Bucks Creek 1101- PM# [REDACTED] Overview Map

Subject: O8W-PM [REDACTED] - Bucks Creek 1101 Phase 1,2&3 - Pre-Engineering Meeting

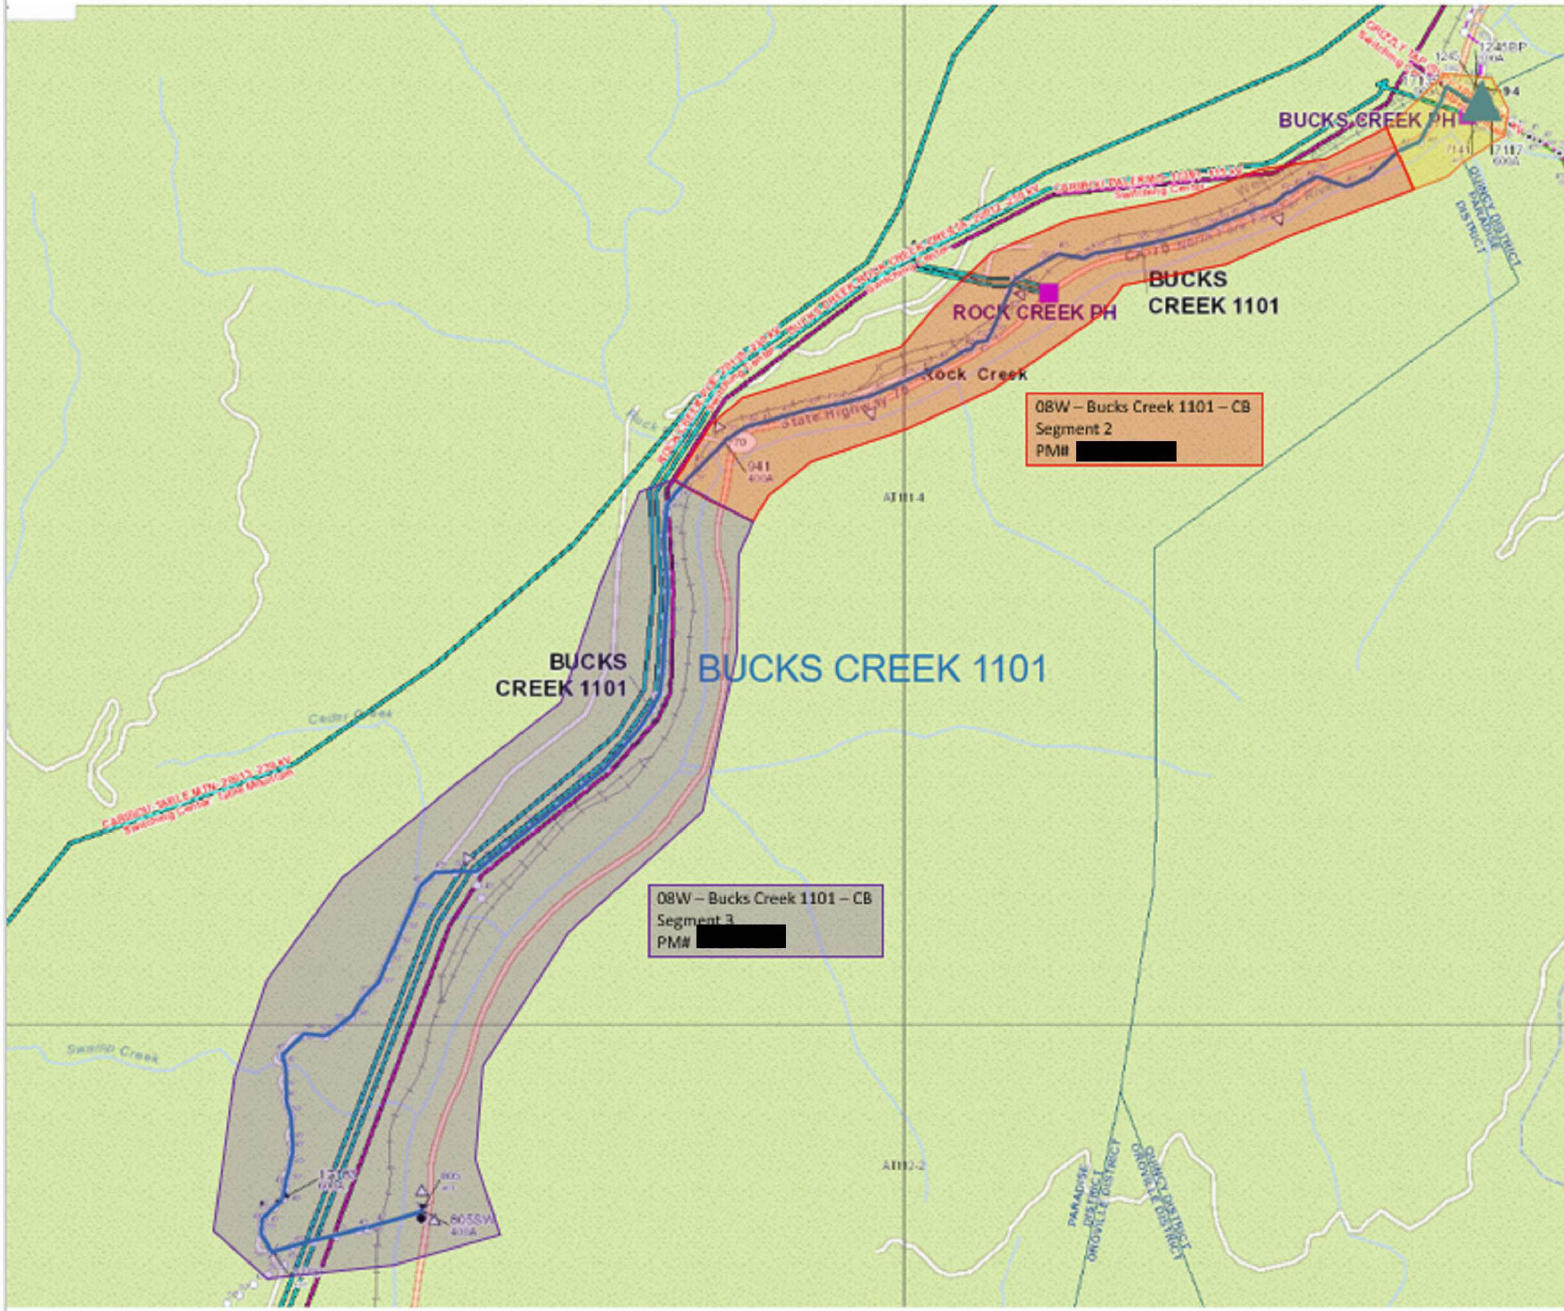
Attached are the 'base-map' limits in a kmz. file. As you will see, we need our base-map to go about ~100' into the tunnel at the south end (see pedestal in picture below....please begin about ~50 beyond this point which is about ~100' beyond the Cresta Dam).

We want to end the base-map at the sign location below which is roughly at MM (Mile Marker) 5.10.
